ADDENDUM NO. 2
Page 1 of 4

VILLAGE OF MIDDLEFIELD, OHIO
WWTP TERTIARY FILTER IMPROVEMENTS PROJECT

ADDENDUM NO. 2

April 20, 2026

DRAWING D-03 DEMOLITION FILTER/DEWATERING BUILDING FILTER ROOM FLOOR PLAN – Delete Drawing D-03 and replace with the attached Drawing D-03.

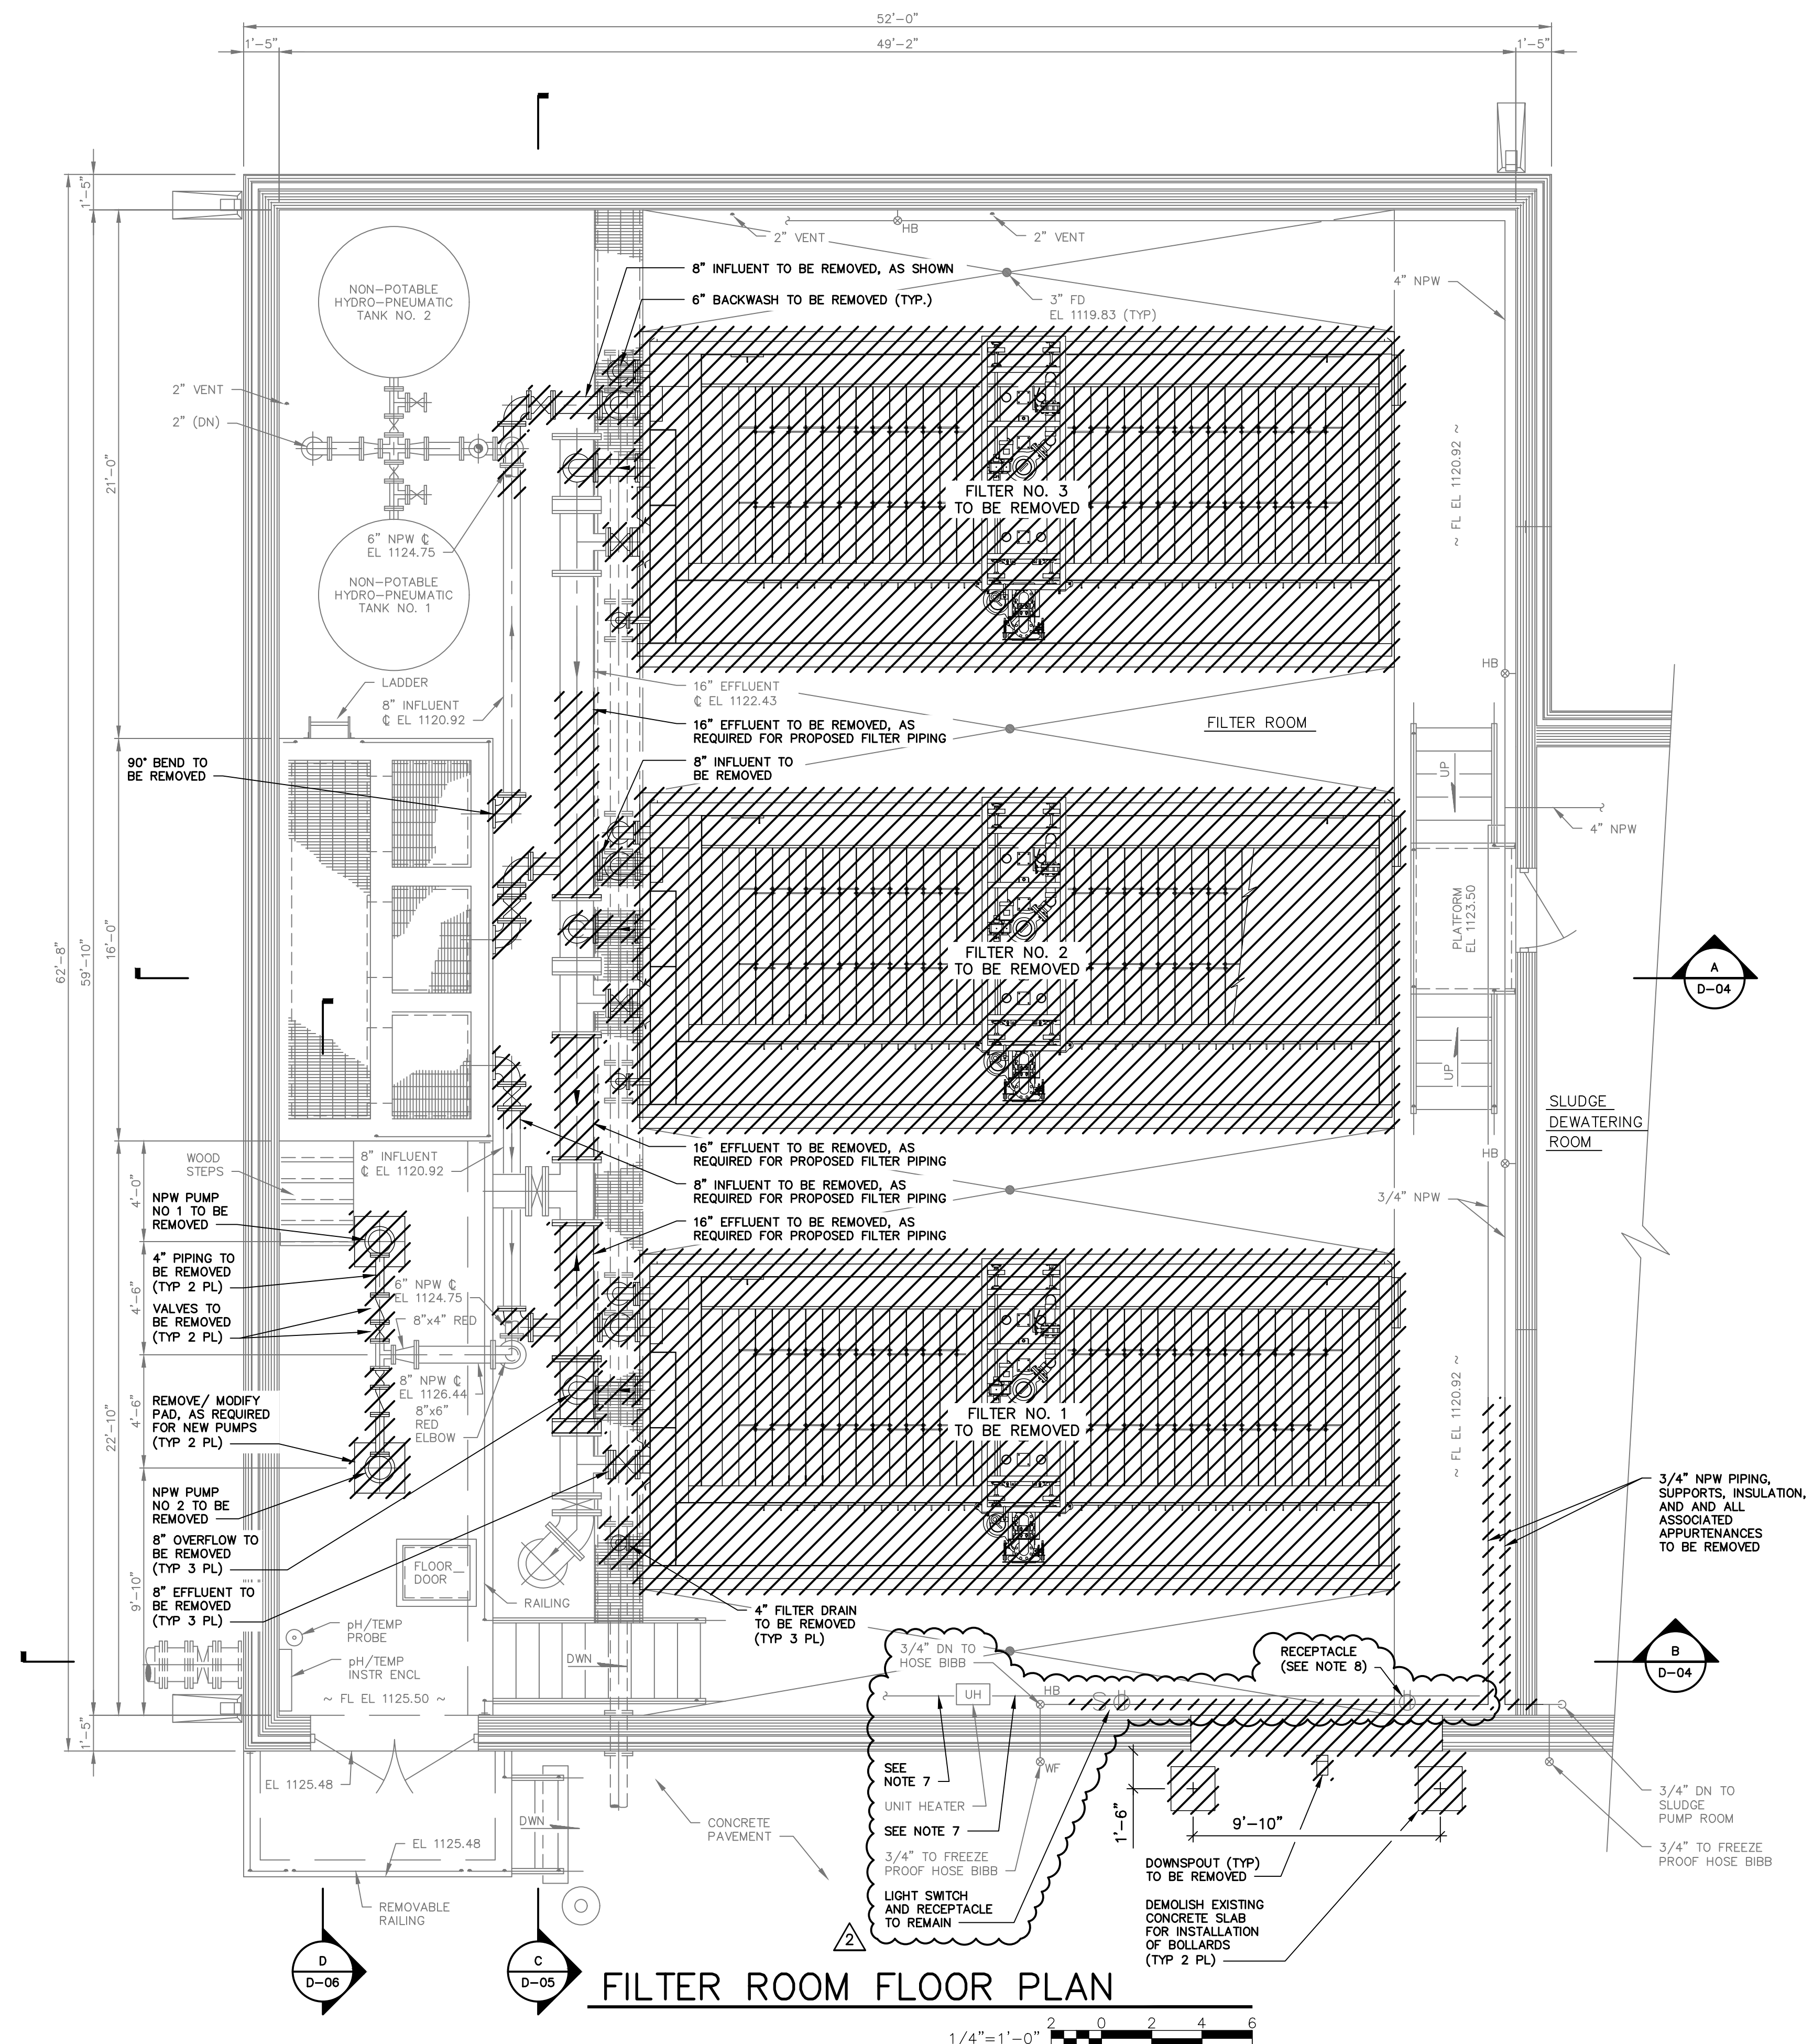
- Q5. Please confirm there are existing conduits and light switch on the South wall of the Filter Room that will need to be relocated for the new overhead door.
R5. *Existing conduit for fire alarm and a unit heater will need to be relocated along with 1 duplex receptacle. The nearby light switch is outside the extents of the shown wall demolition. See revised Demo Drawing D-03.*

- CONTRACTOR SHALL REMOVE ALL DEBRIS, FILTER MEDIA, ACCUMULATED SOLIDS FROM THE FILTER UNITS AND DISPOSE OF SUCH ITEMS PROPERLY.
 - EXISTING 3/4" CONDUIT/WIRING FOR UNIT HEATER AND 3/4" CONDUIT/WIRING FOR FA DEVICES. RELOCATE AROUND EXTENTS NEW OVERHEAD DOOR OPENING.

- EXISTING DUPLEX RECEPTACLE. RELOCATE TO EAST OF EXTENT OF NEW OVERHEAD DOOR OPENING AND EXTEND CONDUIT AND WIRING.
